Final Debris Removal Activities Summary Report

**Area of Contamination 50 – Debris Pile C
Former Fort Devens Army Installation
Devens, Massachusetts**

Project Name: Former Fort Devens Army Installation			
Location: Devens, Massachusetts		Reviewers: Shawn Lowry (USEPA) and Joanne Dearden (MassDEP)	
Document Name: <i>Draft Debris Removal Activities Summary Report, Area of Contamination 50 – Debris Pile C, Former Fort Devens Army Installation, Devens, Massachusetts, October 2023</i>			
Prepared By: Seres-Arcadis 8(a) JV			
No.	Ref. Page / Para.	COMMENT	RESPONSE
Shawn Lowry (USEPA) – December 1, 2023

Figure 3
DB-1 Integrated Interpretation
Debris Pile Removal Report
Devens, Massachusetts

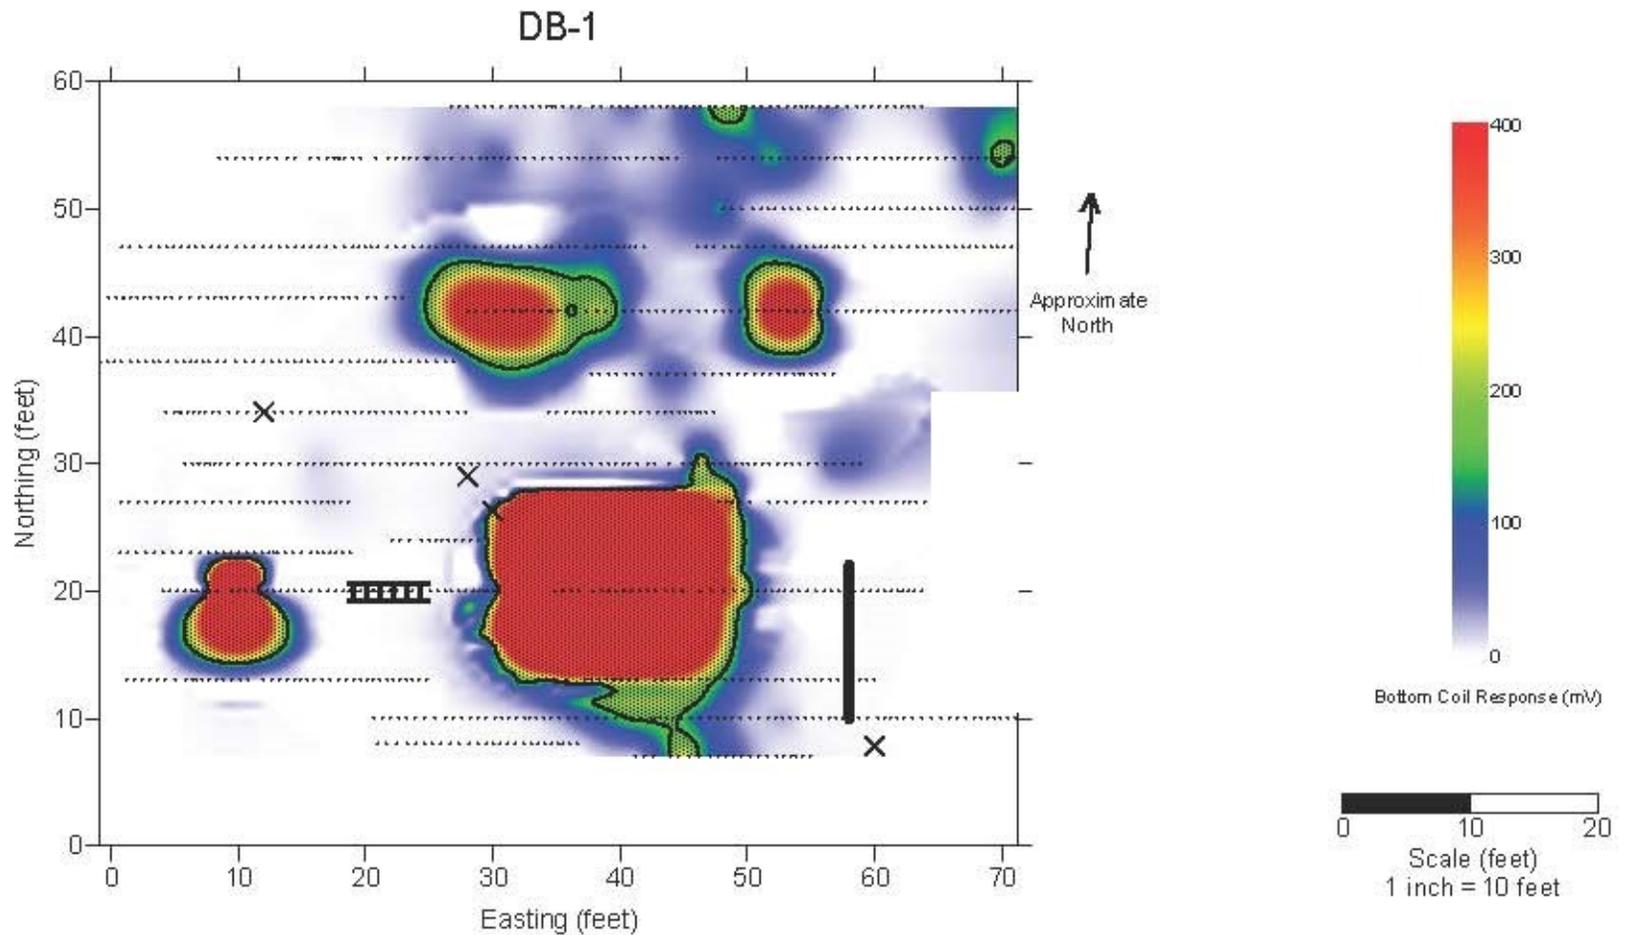
1.	General	The geophysical Survey report (Appendix B) identified several anomalies in the subsurface, including one area in DB-1 that “is large enough to be caused by drums, caches of drums, or other metal debris” (PDF page 36). Army did not propose follow up actions to identify or characterize this material; please provide justification in the text.	As noted in the Work Plan Addendum, the objectives of this work were to remove identified debris to visual limits, document the debris removal actions, and document areas of remaining debris that could not be removed. These objectives were accomplished. A brief statement indicating the objectives of the Work Plan Addendum were achieved has been added to Section 4.
